**SSSD-94006708 State Significant Development**  
**Mixed Use Development at 15-21 Cottonwood Crescent**  
**Macquarie Park 2113, City of Ryde Local Council Area**  
**Current Status: Exhibition**

# Blatant misrepresentation of the streetscape on Herring Road

Figure 74. Section B (Herring Road View) Figure 74 Section B (Herring Road View) page 34 Urban design and architect's report Appendix E.

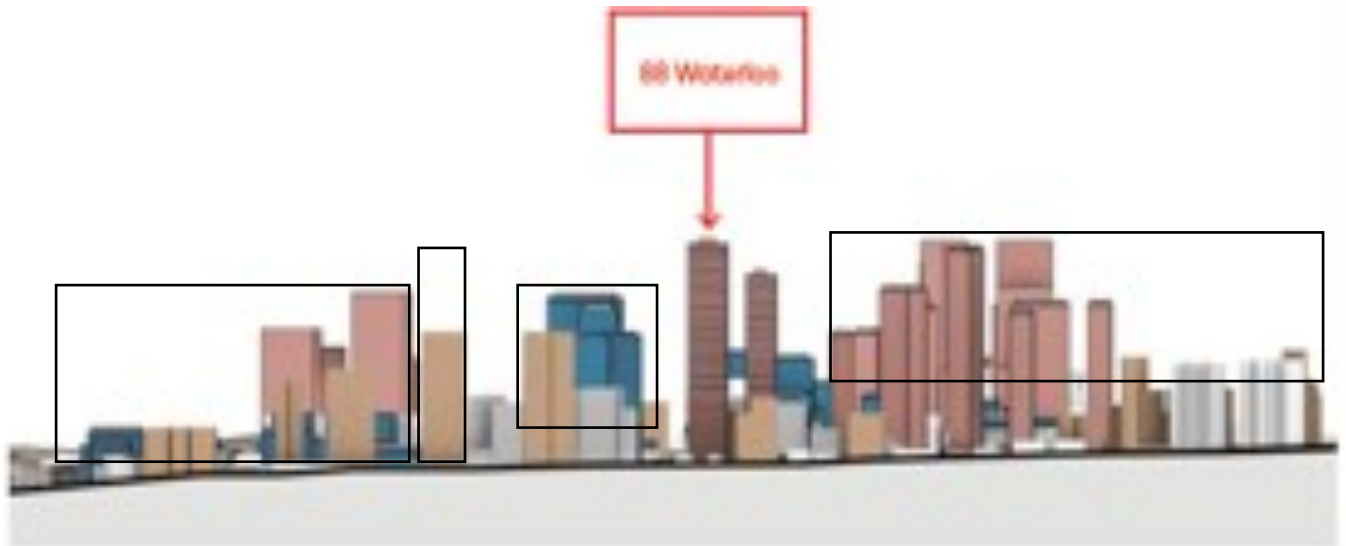
Box 1. these buildings don't exist and never will as they would be located directly on the M2 motorway.

Box2. This building *does* exist. It is Trilogy by Meriton and is the only building in Macquarie Park that is 60 storeys high, or over 22 storeys high.

Box 3. This is the northern entrance to Macquarie Centre. It is one and a half storeys high at this location, nor are there any buildings visible above it.

Box 4. There is not a single development over 22 storeys anywhere on this side of Herring Road built, or approved for development.

Figure 74. Section B (Herring Road View)

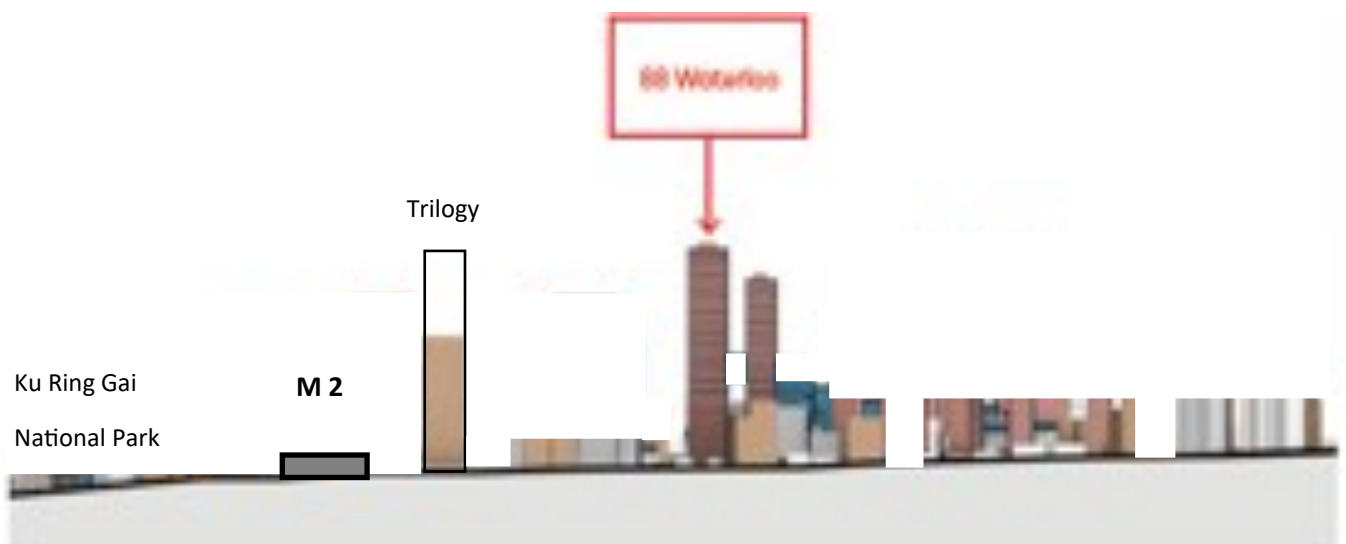
Drawn to scale the true streetscape of Herring Road to Epping Road.

Figure 52 Potential visibility from immediate and surrounding dwellings to part of the proposal

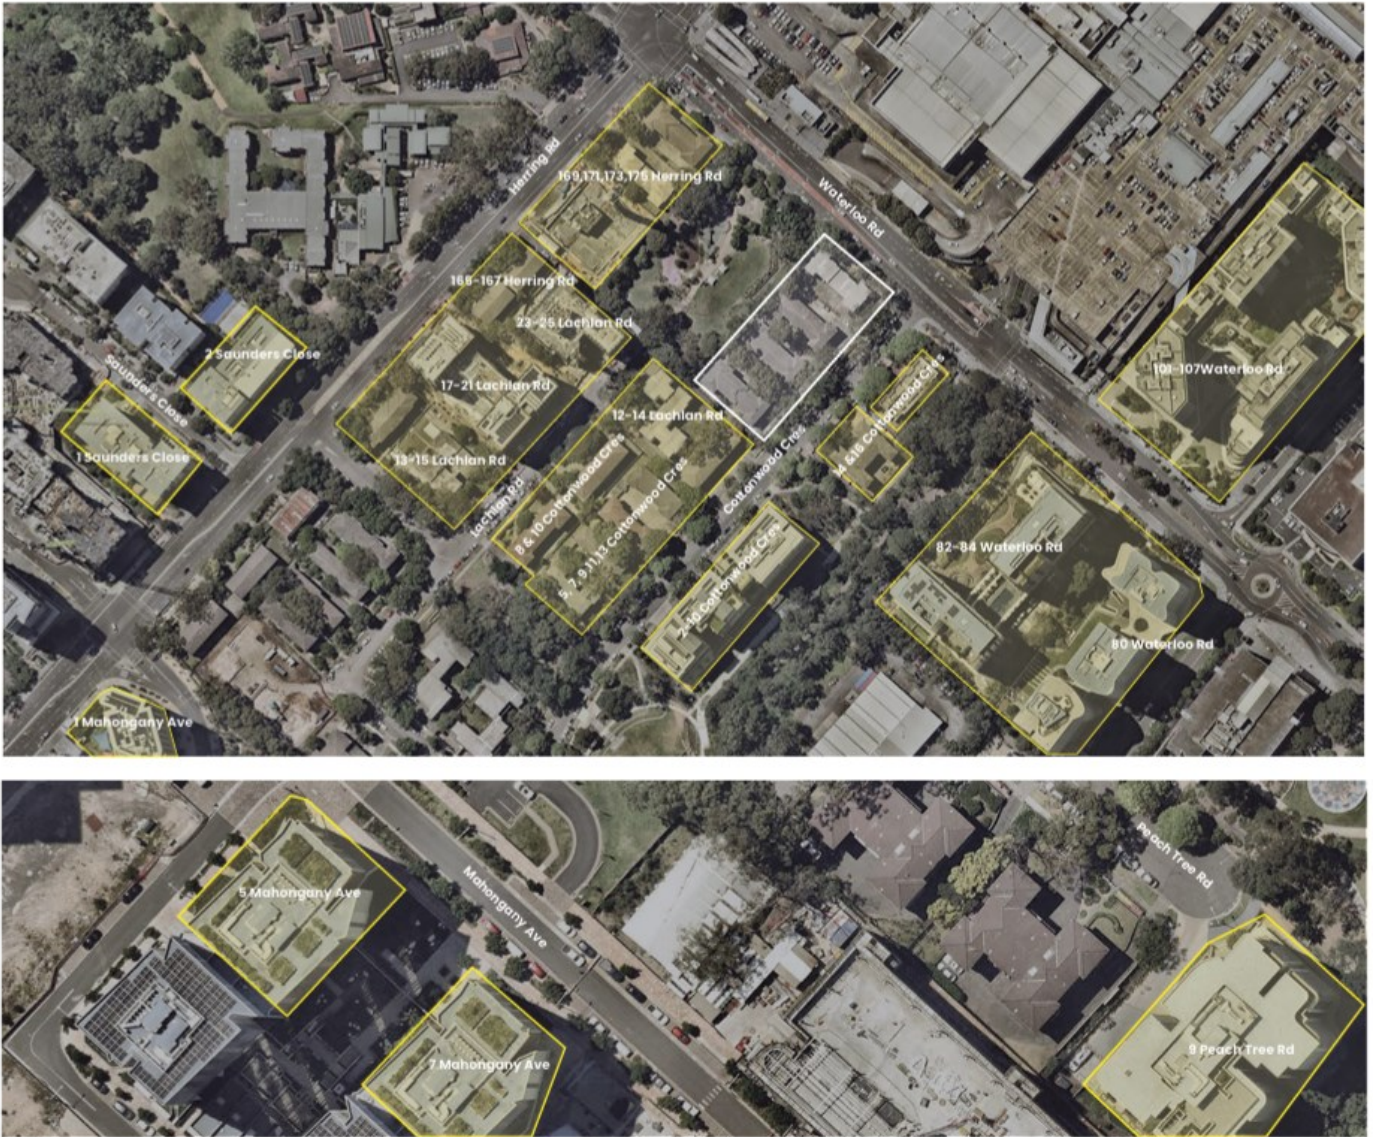
The white box in the upper right is the development site of 15-21 Cottonwood. The yellow boxes identify the building sites of neighbouring developments either under construction, the block size of those able to be developed, or those already completed. Six sites in the upper photo have been completed, with four more currently under construction or almost finished. Every one of these developments are either 16 or 20 storeys high. For the Impact Assessment report to conclude that there is low to medium impact on the nearby environment is farcical. Visually (the report claims other large towers will soon be built near by, thus normalising its initial height impact) overshadowing (significant shadows will impact every building surrounding it due to the path of the sun starting from directly south of the building in the morning (to the right of this picture) and setting north of it at night (top left of the picture) heat and light reflection (the impact report failed the development for this due to projected outcomes on the building's southern neighbours, with no adequate solutions presented) amenities (the park directly north will be in shade until late afternoon).

Response: there is only one development of this size in Macquarie Park and it is located almost a kilometre away in isolation from the primary development corridor. All other buildings are limited to 16 to 22 storeys as per the building code. As such, the agenda informing the logic of this assessment is based on the incorrect assertion that this proposal is an actual reflection of current and future developments which will normalise buildings of this size in Macquarie Park. It is not. It is an anomaly that will have a severe impact on over nine neighbouring developments within metres from the site.
